City of Plymouth Planning Commission

Regular Meeting Agenda

To: Planning Commission
From: Greta Bolhuis, AICP, Planning and Community Development Director
Date: October 8, 2026
Re: Final PUD Review of PUD26-01: 639 S. Mill and 166 E. Ann Arbor Trail

Wade Trim Associates, Inc.
25251 Northline Road • Taylor, MI 48180
734.947.9700 • www.wadetrim.com

Figure 3. Screen Wall Locations and Landscape Strip Location

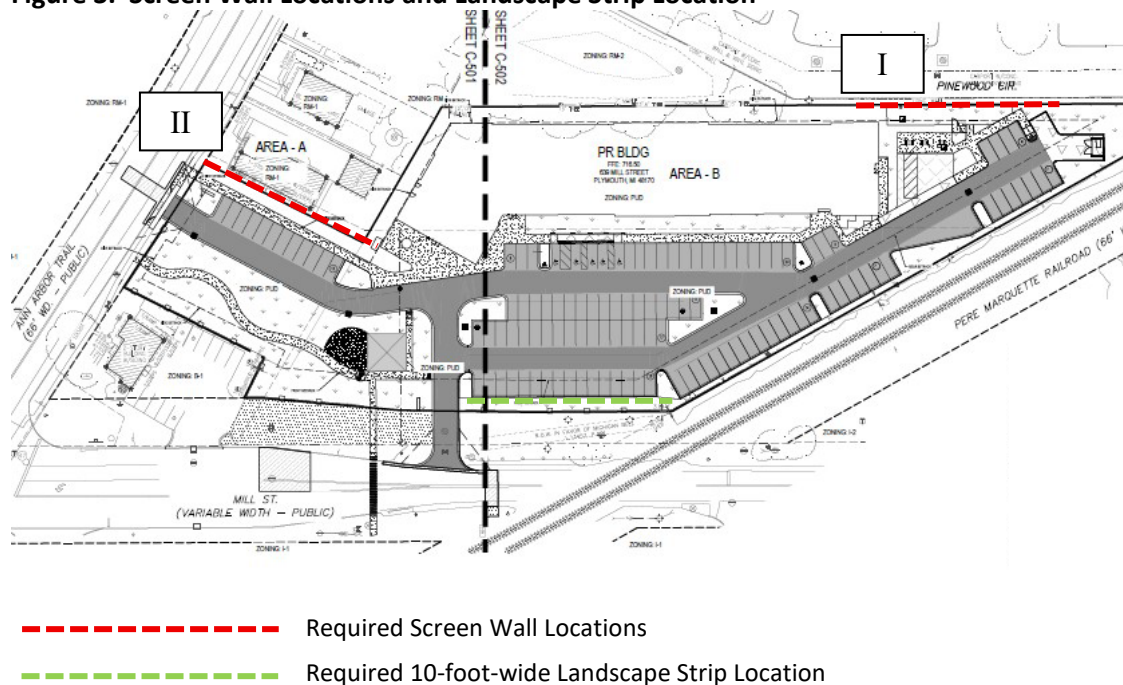
- **Screen Wall Area – Red Line Labeled “I” In Graphic Above**

Pinewood Condominiums has a six-foot-tall masonry screen wall between the Lumber Mart site and their carports; therefore, no new wall is necessary. (Note that there is an inconsistency between the rendering of the Dog Park (Sheet G.004) and the Landscape Plan (Sheet L-202). The rendering shows trees along the east side of the Dog Park, but no trees are proposed in this location on the Landscape Plan. There are also no trees on the adjacent property (Pinewood Condominiums) next to the Dog Park. This area is occupied by the screen wall and carports.)

**EXISTING
CONDITIONS- AREA
A**

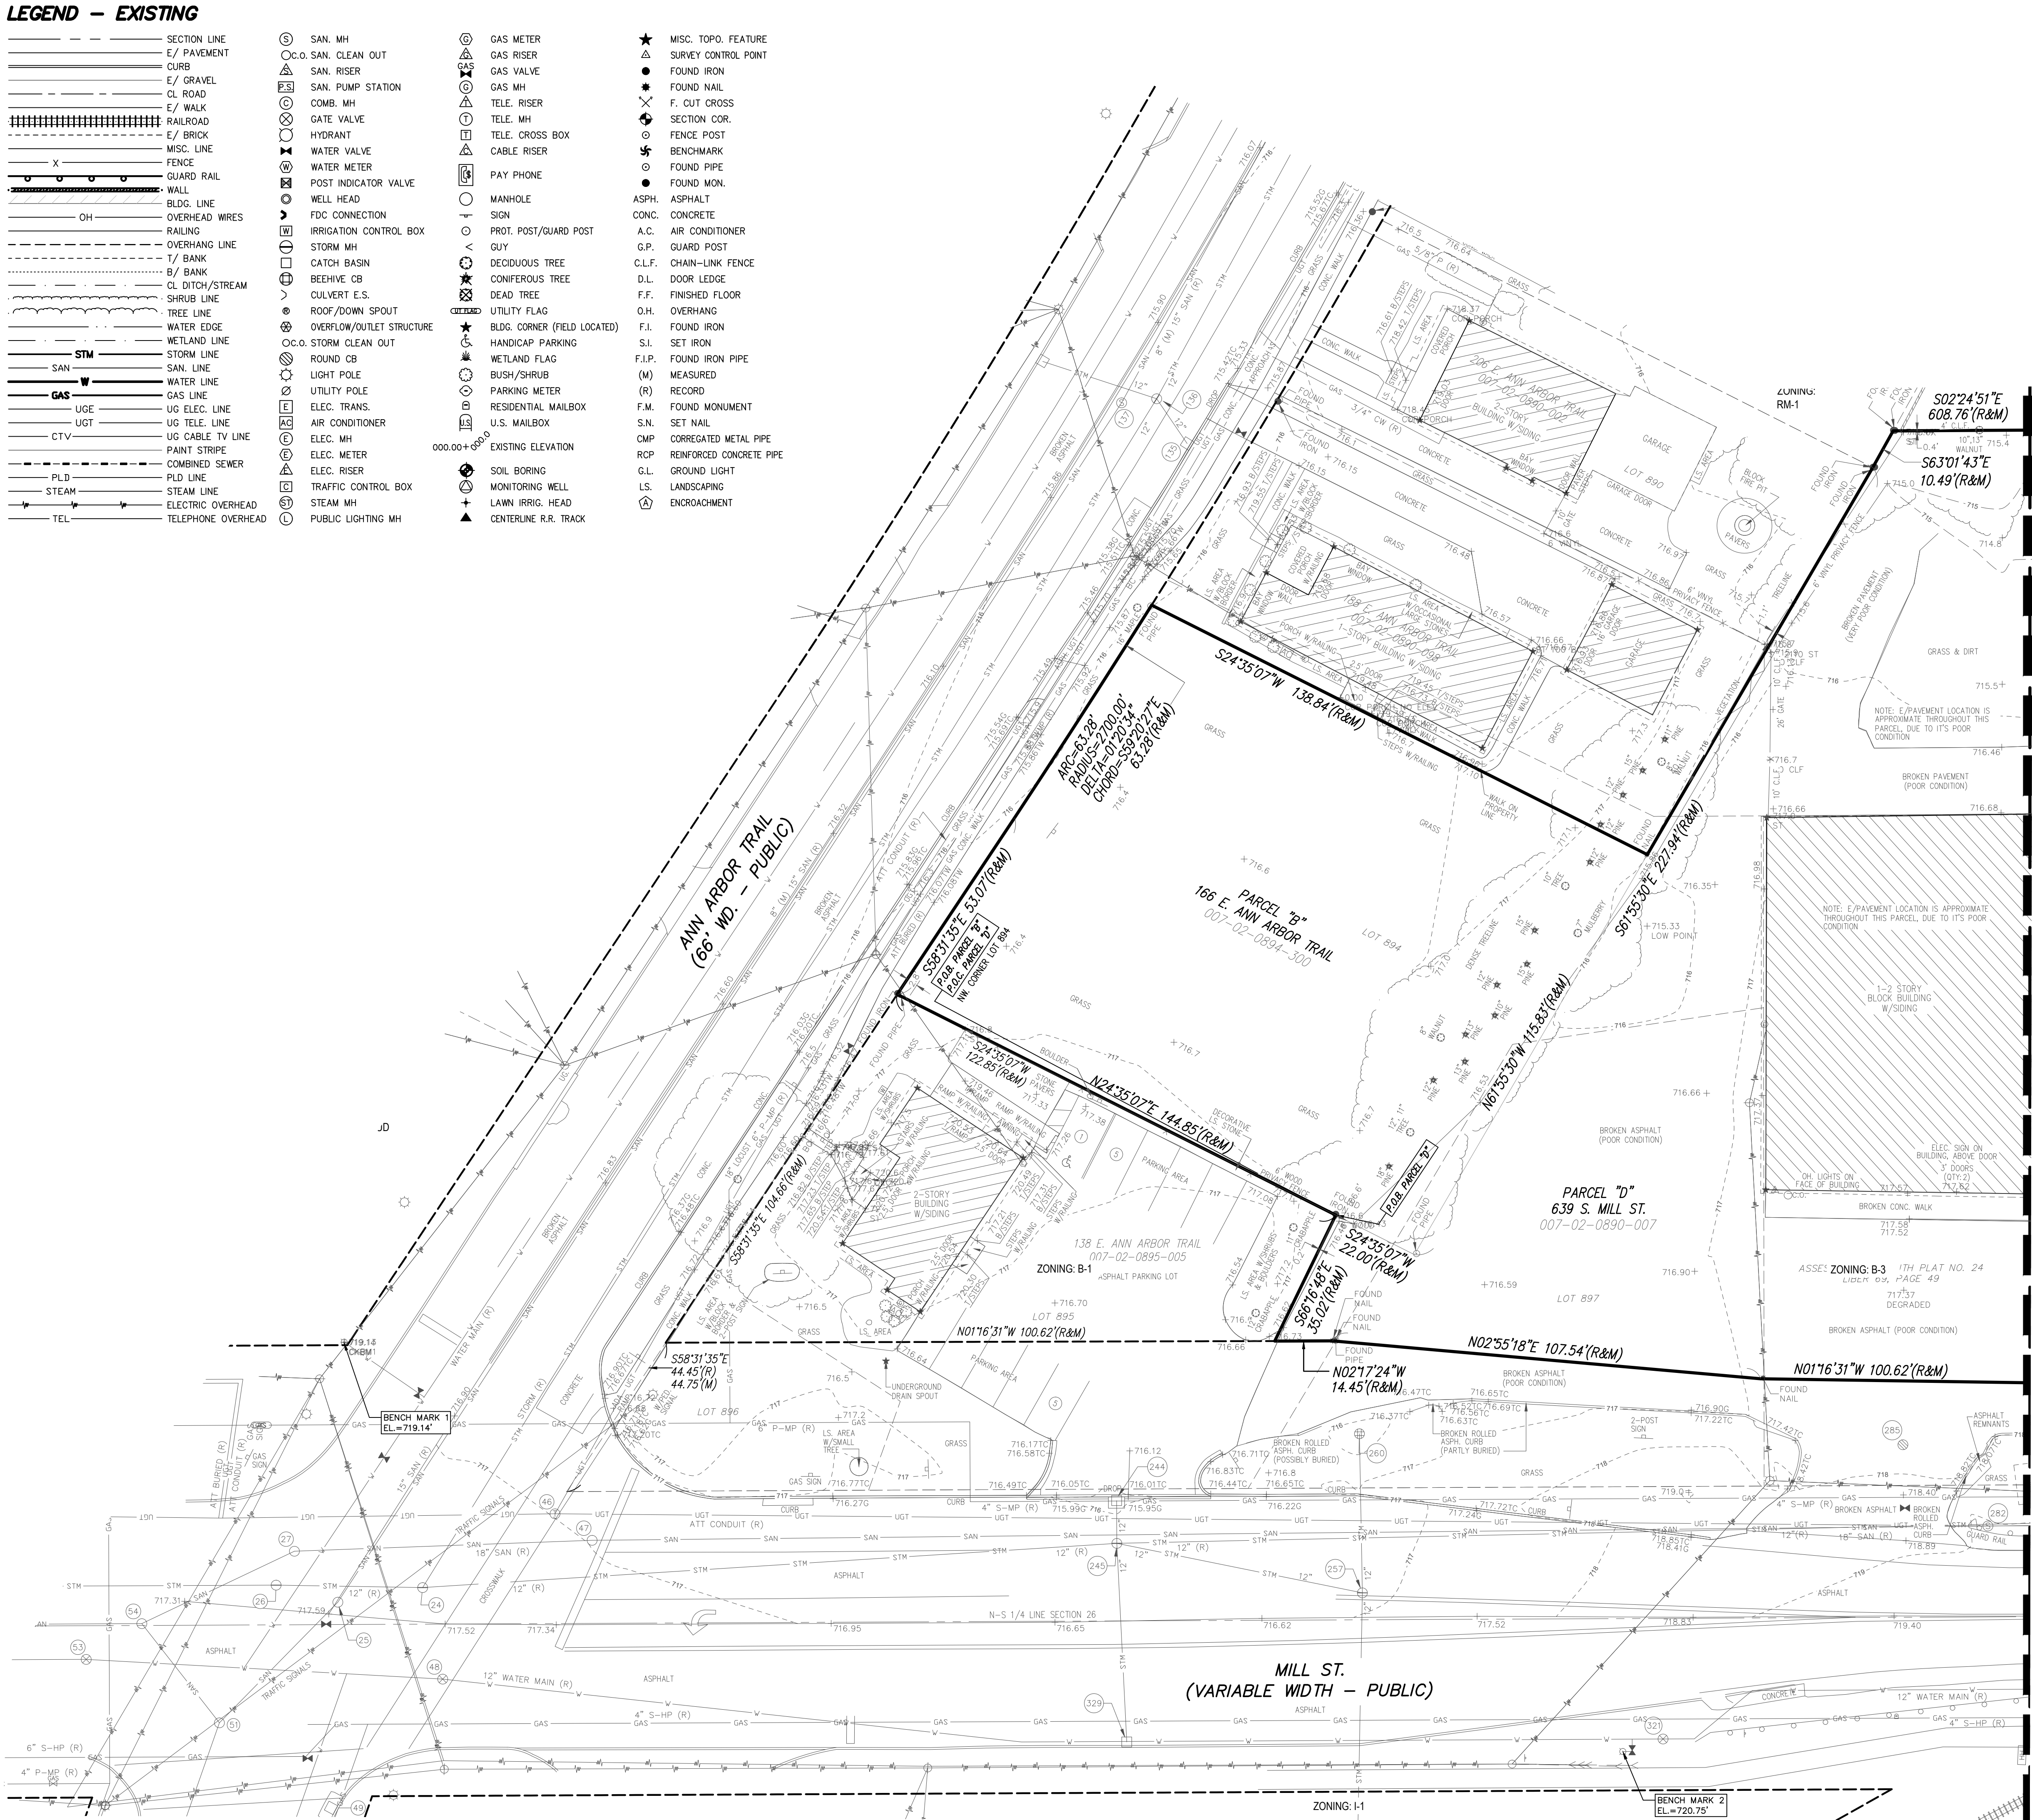
- A. The property does not appear to fall within any regulated flood plain.
- B. The cover sheet indicates that the topographic survey was collected in April 2016. Per the benchmark data shown on the plan sheet C-200 “Existing Conditions Overall”, the North American Vertical Datum (NAVD 88) was utilized. The horizontal datum does not appear to be noted. Four benchmarks are shown on the plans that have been submitted. The benchmarks should be protected during any future construction.

UTILITY PLAN -
AREA A

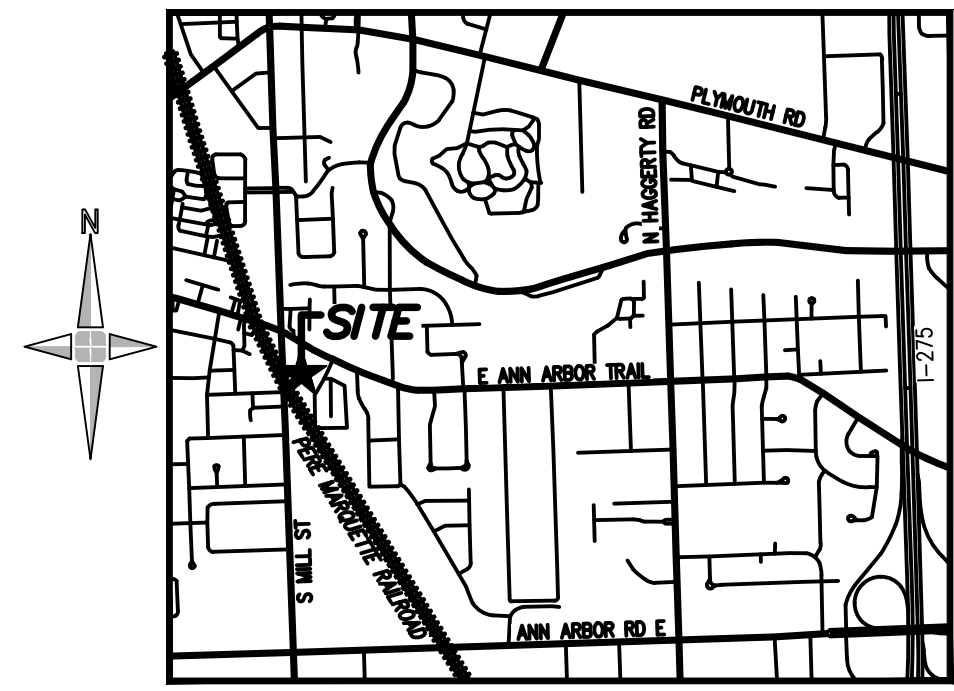
- C. Utility Plan Sheet C-700 proposes new water main as part of the project. The proposed size and material for the new water main does not appear to be shown on the plans. A minimum size of eight inches will be required and an Act 399 permit from the State of Michigan Department of Environment, Great Lakes, and Energy (EGLE) will be required for all new water main. Following final engineering approval, the Developer will be required to provide sufficient information to assist the City with the required permit application.

- A. The existing water main on Ann Arbor Trail is shown on Utility Plan sheets C-700, C-701, and C-702. We believe that the existing water main on Ann Arbor Trail is 6-inches in size and likely cast-iron pipe. The existing water main size should be confirmed and added to all utility plan sheets.

- B. The existing water main on Mill Street is shown on Utility Plan sheets C-700, C-701, and C-702, however, we do not believe that it is shown correctly. The existing water main is 12-inch fusible PVC water main and was installed by the City (pipe bursting) along Mill Street in 2015. A copy of our record plan sheet can be provided to assist the applicant in drawing the location of the 12-inch existing water main on Mill Street.

- A. Stormwater Detention has been identified as part of this project, with limited details. Utility Plan Sheets C-700, C-701, and C-702 propose an on-site underground detention system in the parking area just south of the proposed driveway entrance off of Mill Street. The underground detention system is currently proposed for a 10-year rain event storage volume.
- B. It is unclear if any water quality devices are being proposed for this project.
- C. The applicant will be required to follow the Wayne County Storm Water Ordinance for this project, especially given that they will be discharging directly to the Mill Street right-of-way.

CONCRETE BOLLARD

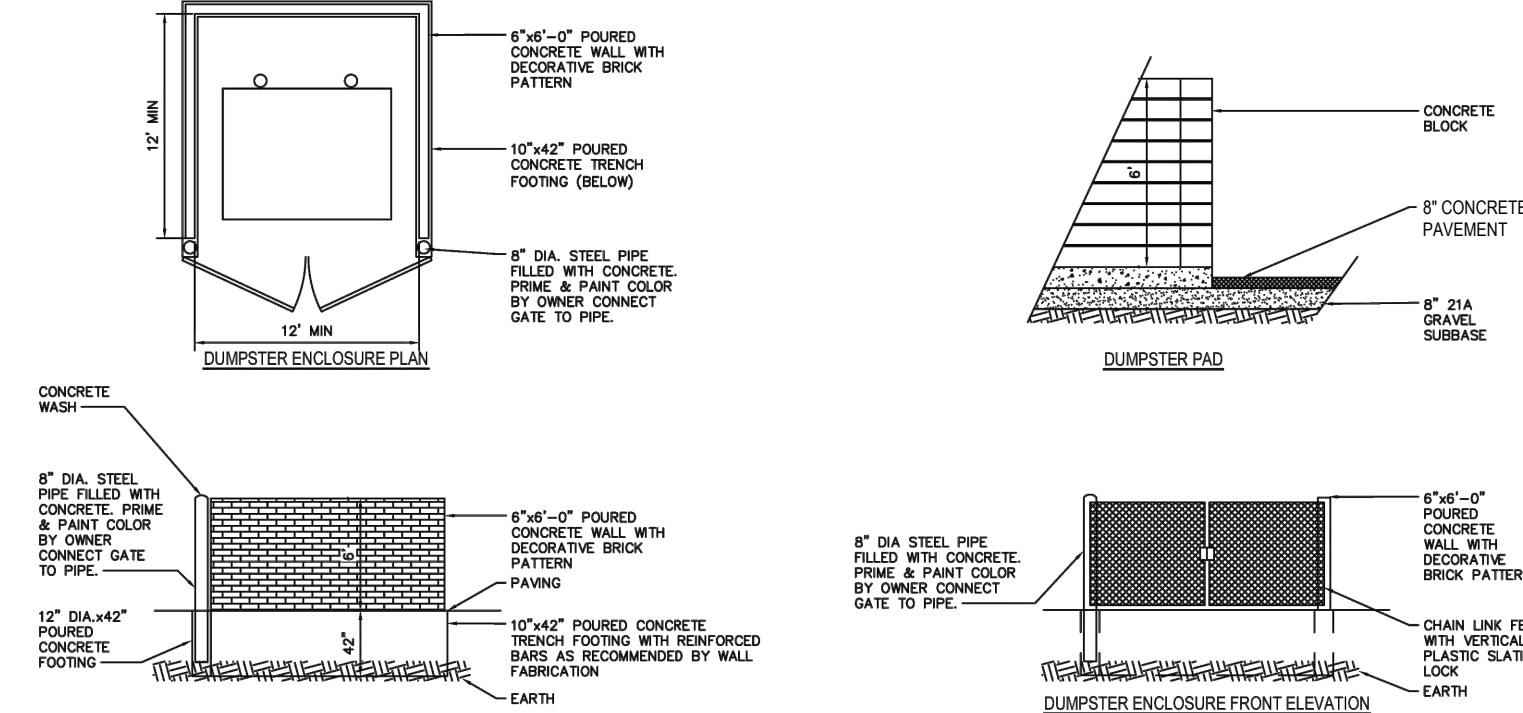
CWA Comment: Sheet C-502, *Geometric & Paving – Area B*, and Sheet C-810, *GW Details*, show proposed concrete bollards between the patio and loading areas.
